RE: TOWN PARK PHASE III, FINAL PLAT AND CERTIFICATE OF
OCCUPANCY APPROVALS (K-21/DB)

RE: GRADING PLAN SUBMITTAL OF TOWN PARK, PHASE III RECREATIONAL
PARK, RECEIVED SEPTEMBER 29, 1986 FOR BUILDING PERMIT
APPROVAL (K-21/DB)

RE: DRAINAGE REPORT SUBMITTAL OF TOWN PARK PHASE III & IV
RECEIVED APRIL 3, 1986 FOR PLATTING APPROVAL AND ROUGH
GRADING PERMIT (K-21/D/8)

**ADDENDUM TO
DRAINAGE REPORT
FOR
TOWNE PARK**

TOWNE PARK PHASE III RECREATIONAL PARK

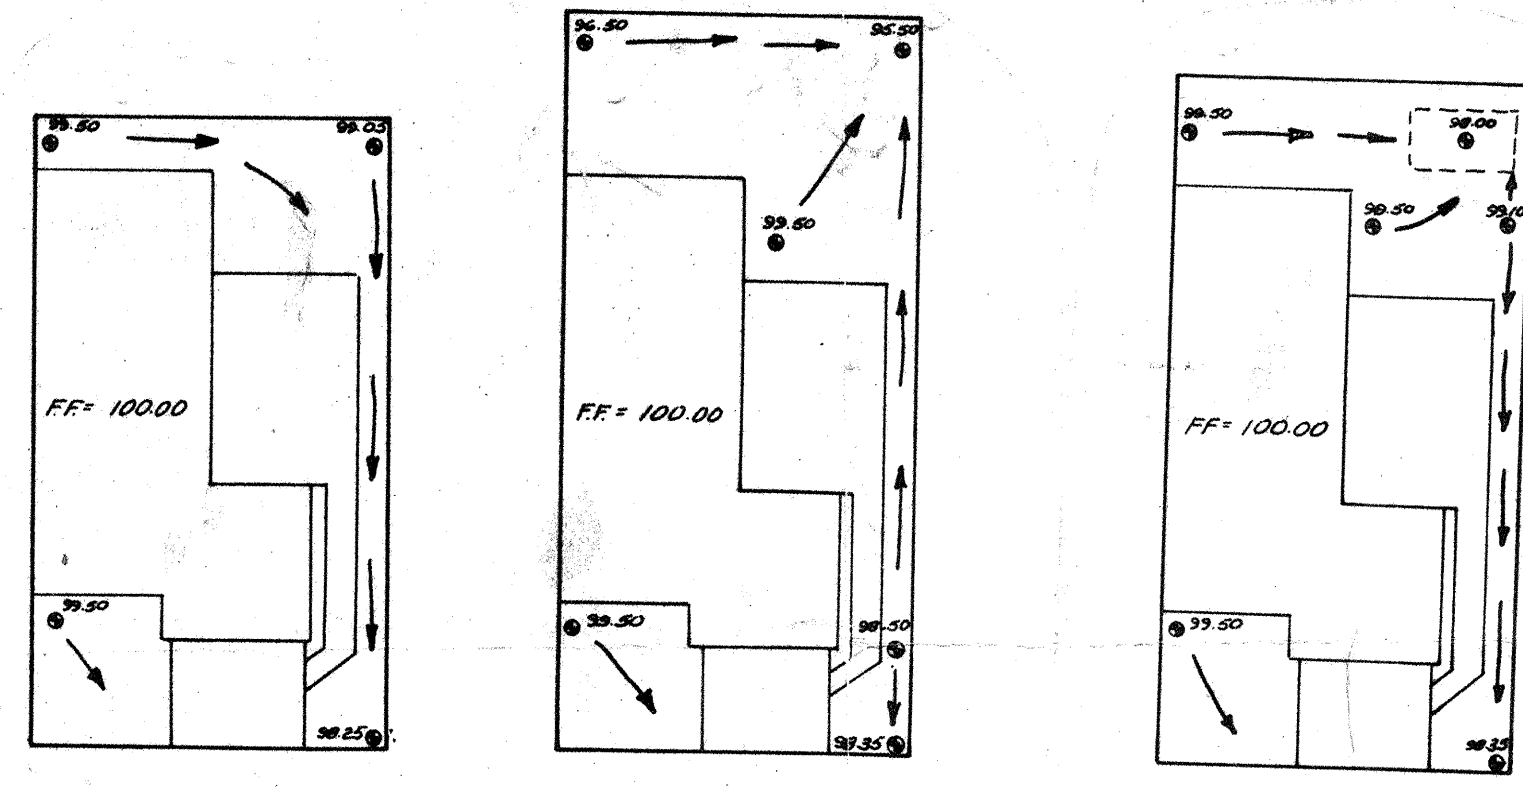
The above referenced submittal, dated September 29, 1986, is approved
for Building Permit sign-off by Hydrology for the pool building.
Include this approved plan with the construction sets routed for
permit sign-off.

My previous memo, dated April 18, 1986, approving Phases III & IV for
Preliminary Plat and Rough Grading Permit failed to require that a
separate "Permit to Construct Private Storm Drain Improvements" (S.O.
#19) is required to connect the private 18" RCP in Chico Road.
